APPLICATION FOR ZONING CHANGE

NAME OF PROPOSED DEVELOPMENT PANNELL SUBDIVISION

SITE PLAN REVIEW

## PANNELL SUBDIVISION DEVELOPMENT PLAN

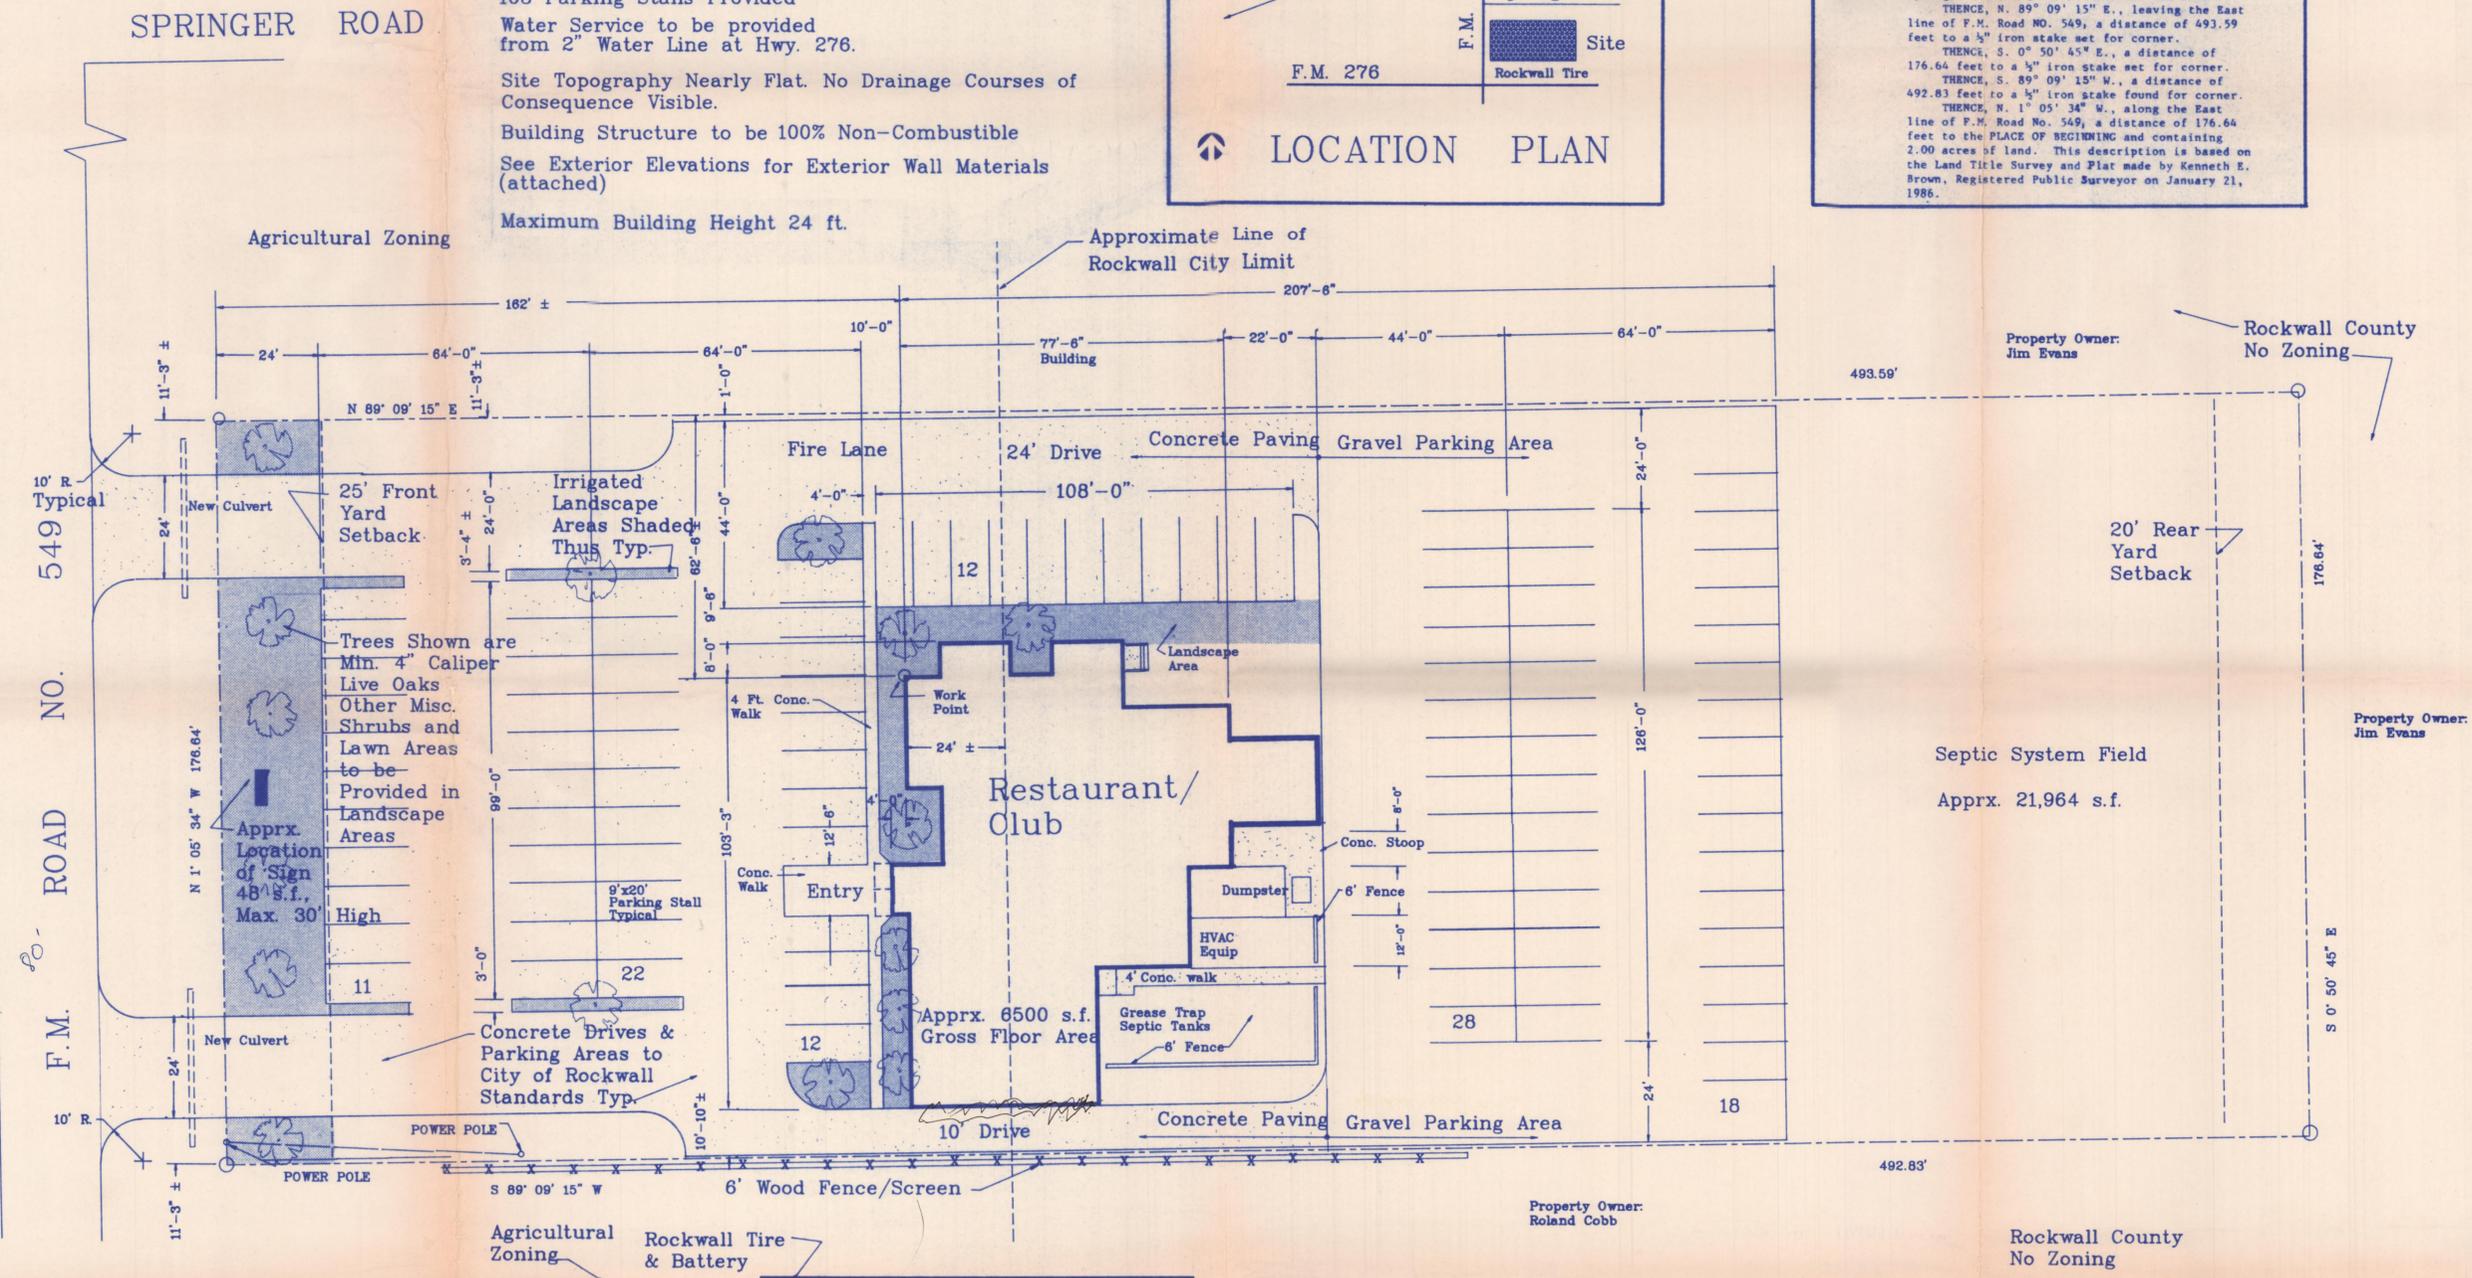
d. Landscaping <i>- needs to add 5-10 feet of</i>	_____	_____	_____
e. Parking <i>57 in concrete</i>	_____	_____	_____
f. Lighting <i>46 in gravel</i>	_____	_____	_____

*need to add 20804 for street*

*add landscaping to parking lot*

- 7. Does the site plan contain all required information from the application checklist?  Yes  No  N/A
- 8. Is there adequate access and circulation?  Yes  No  N/A  
*the 10' drive is too narrow side walk to*
- 9. Are street names acceptable?  Yes  No  N/A
- 10. Was the plan reviewed by a consultant? (If so, attach copy of review.)  Yes  No  N/A
- 11. Does the plan conform to the Master Park Plan?  Yes  No  N/A

*drive entrances are not 200' apart - only 104'*

- 1. Do buildings meet setback requirements?  Yes  No  N/A  
*is there a fire wall on side*
- 2. Do buildings meet fire codes?  Yes  No  N/A  
*have one side yard of 10ft - fire wall?*
- 3. Do signs conform to Sign Ordinance?  Yes  No  N/A

- 1. Does plan conform to Thoroughfare Plan?  Yes  No  N/A  
*needs to show 20' ded.*
- 2. Do points of access align with adjacent ROW?  Yes  No  N/A
- 3. Are the points of access properly spaced?  Yes  No  N/A  
*need 200' they have 104'*
- 4. Does plan conform with Flood Plain Regulations?  Yes  No  N/A
- 5. Will escrowing of funds or construction of substandard roads be required?  Yes  No  N/A  
*176.64' of frontage & 2 lanes*

11. Does the plan exhibit good planning in general layout, access, and vehicular and pedestrian circulation?	<input checked="" type="checkbox"/>	<input type="checkbox"/>	<input type="checkbox"/>
<i>except for 10' drive along side - too narrow unless only for service for employees?</i>

d. Is any additional right-of-way required? <i>need 20' on FM-549</i>	<input checked="" type="checkbox"/>	<input type="checkbox"/>	<input type="checkbox"/>

e. Is there adequate road access to the proposed project?	<input checked="" type="checkbox"/>	<input type="checkbox"/>	<input type="checkbox"/>
f. Will escrowing of funds or construction of substandard roads be required? <i>176.64' of funds x 2 lanes</i>	<input checked="" type="checkbox"/>	<input type="checkbox"/>	<input type="checkbox"/>

1. Water	<input checked="" type="checkbox"/>	_____	_____
2. Sewer	_____	_____	<input checked="" type="checkbox"/>
d. Is there adequate capacity in sewer outfall mains, treatment plants and water transmission lines to handle the proposed development? <i>not adequate water service</i>	_____	<input checked="" type="checkbox"/>	_____

- (1) That the 10' South access drive to the rear parking lot be deleted.
- (2) That all escrow requirements for street & water line be met.
